**Preliminary Alternative Technical Concepts (ATC) Submittal**  
**BEL-70-9.35 Interchange Improvement**  
**Design-Build**  
**Belmont County, Ohio**  
**PID 120547**

## Contents

# EXHIBIT D

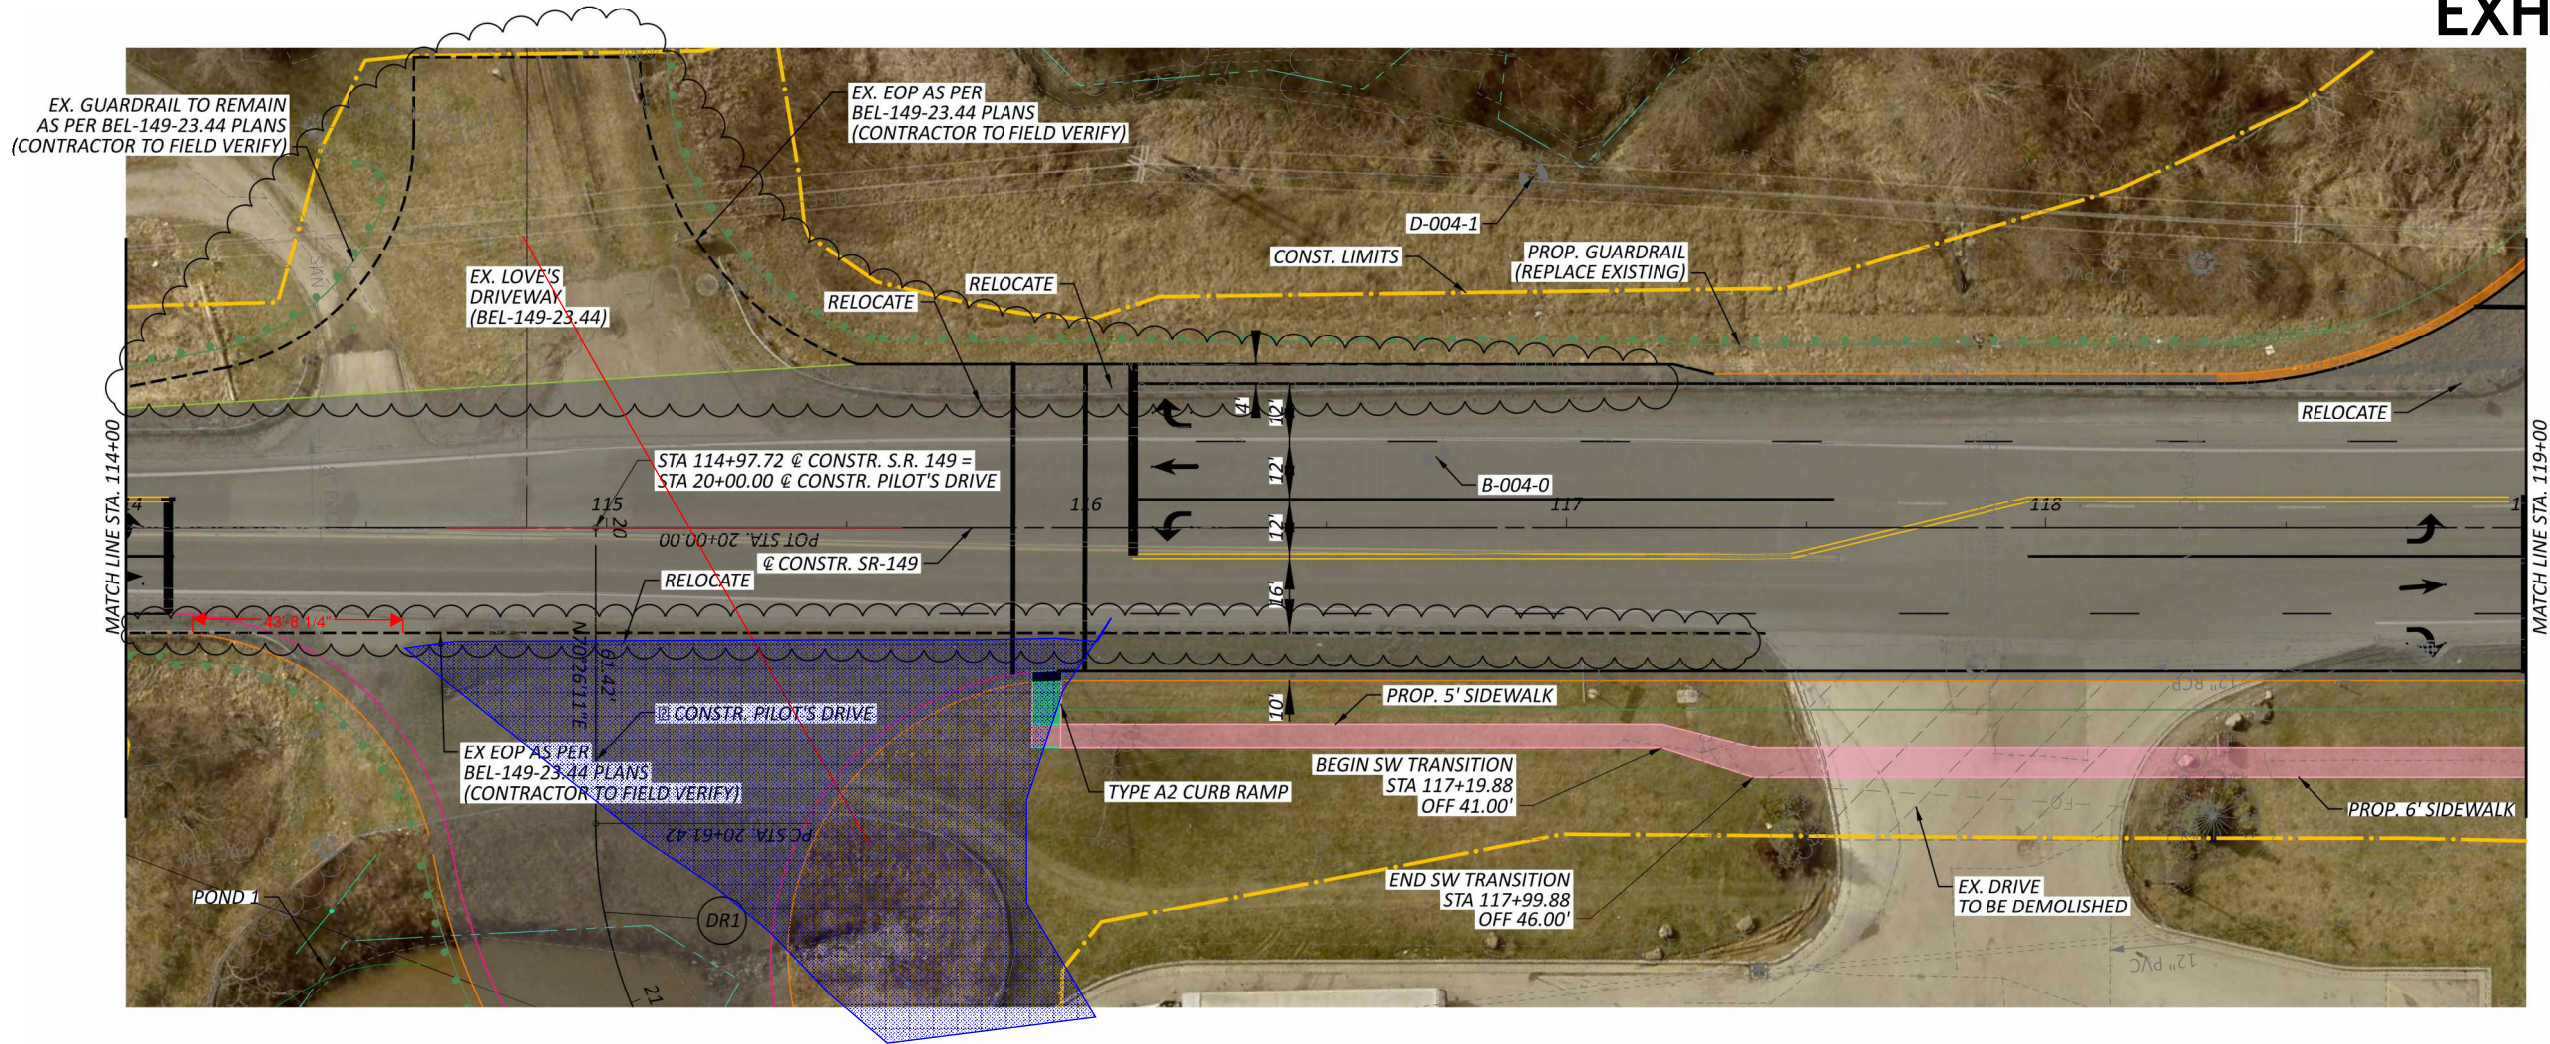
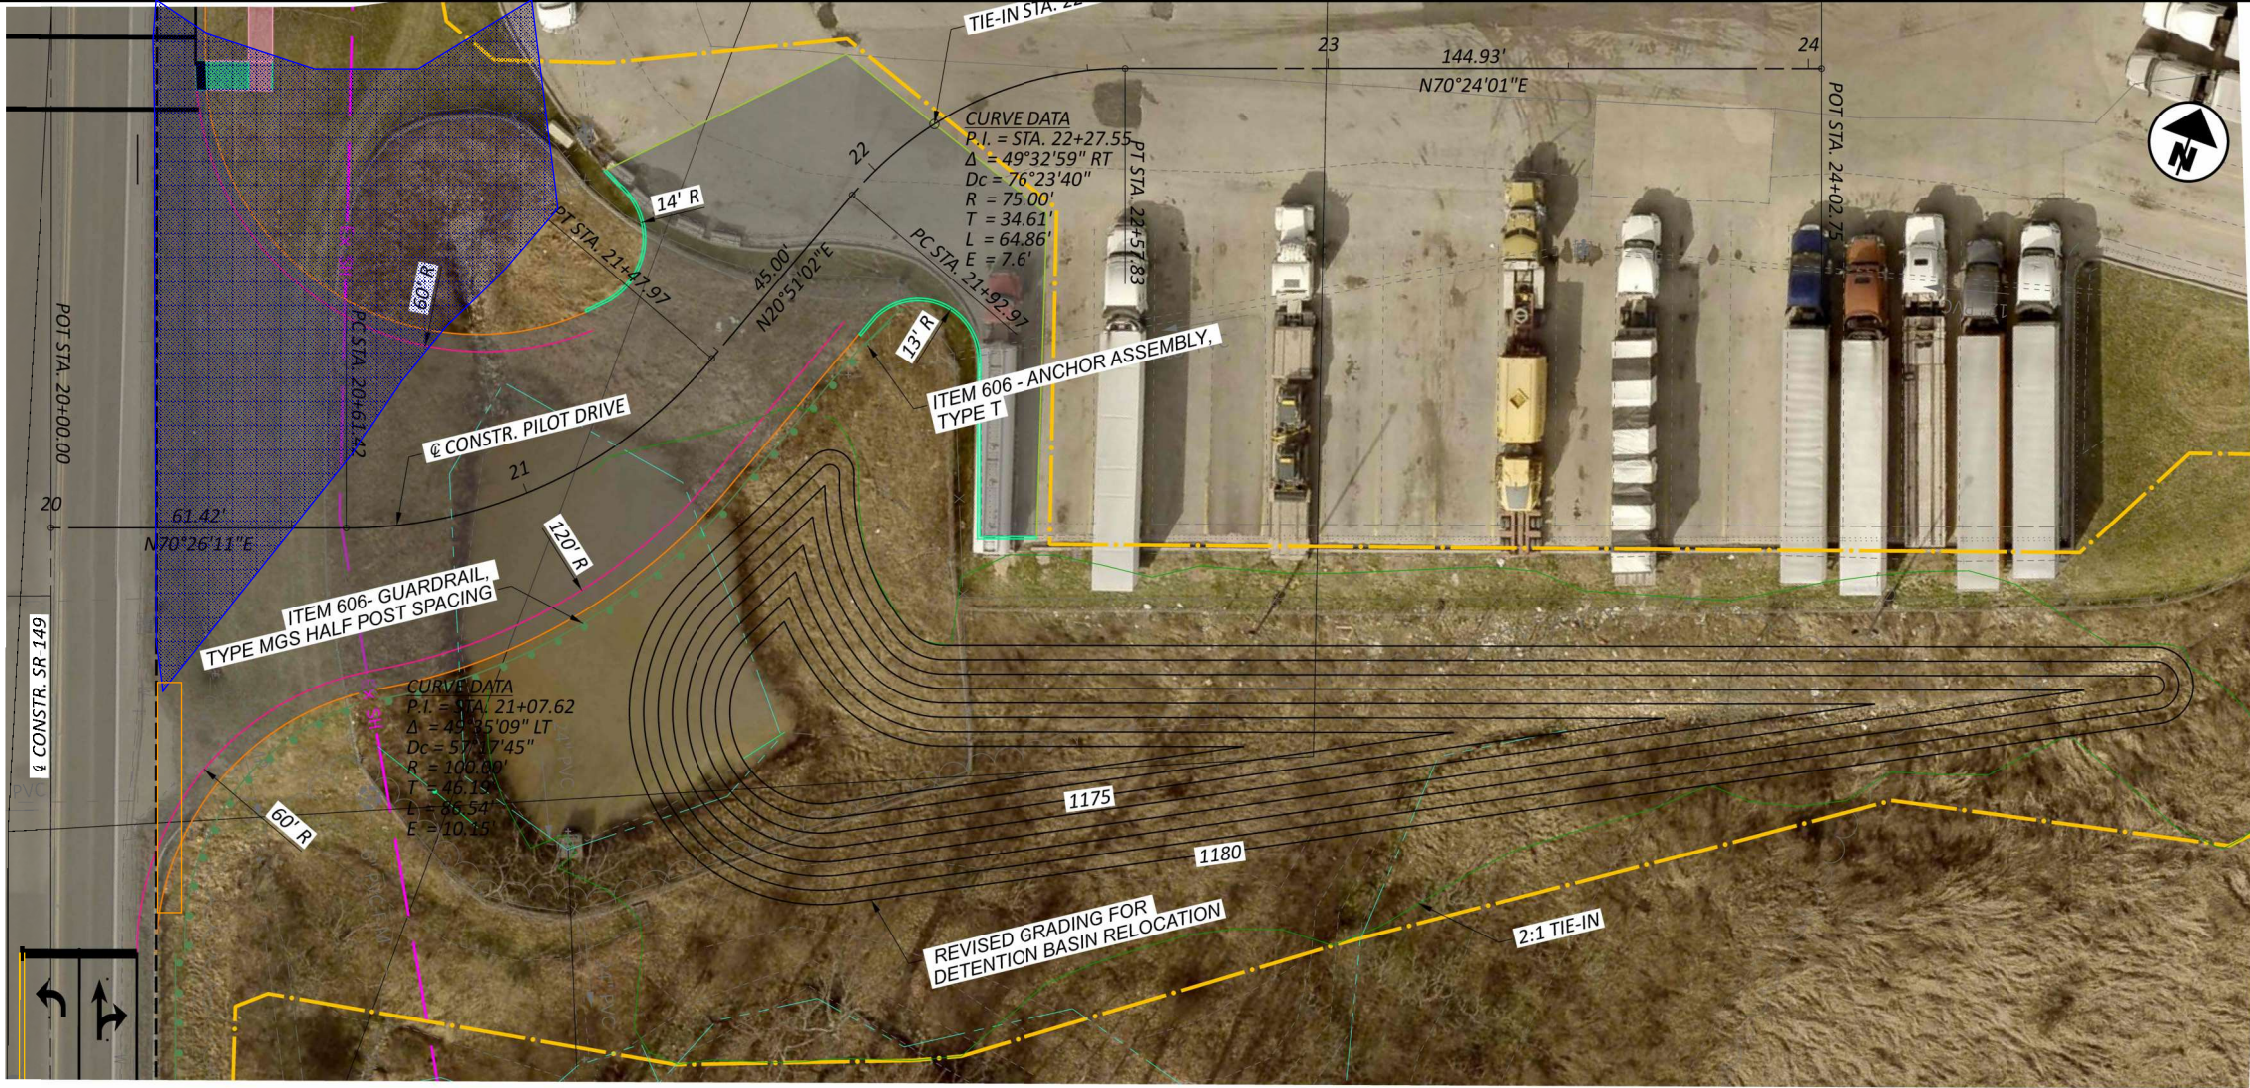
1. **Description:** This ATC proposes a modification to the driveway configuration requirements as outlined on Page 39 of 63 in the BEL-70-9.35, PID 120547 SCOPE OF SERVICES (Addendum 1). The original specification mandates that the DBT follow the geometrics depicted in the Conceptual Plans regarding proposed driveway configurations and existing driveway removals.

The DBT proposes to modify this requirement to design the driveways with input from the driveway owners. This change allows for the incorporation of feedback and specific requirements from the local entities regarding truck traffic control, ensuring that the final driveway configurations meet the needs of these key stakeholders while maintaining compliance with the overall project design. See Exhibit D for additional details.

2. **Deviation:** Page 39 of 63 in the BEL-70-9.35, PID 120547 SCOPE OF SERVICES (Addendum 1) states: *"The DBT shall follow the geometrics depicted within the Conceptual Plans in regard to proposed driveway configurations and existing driveway removals."*

The DBT proposes to modify the above language to: *"The DBT shall design the driveways to geometrics acceptable to the truck stop entities, specifically DR-1 shown on 120547\_Appendix Conceptual Plans, which will have an intersection point between Sta. 114+50 - 116+50."*
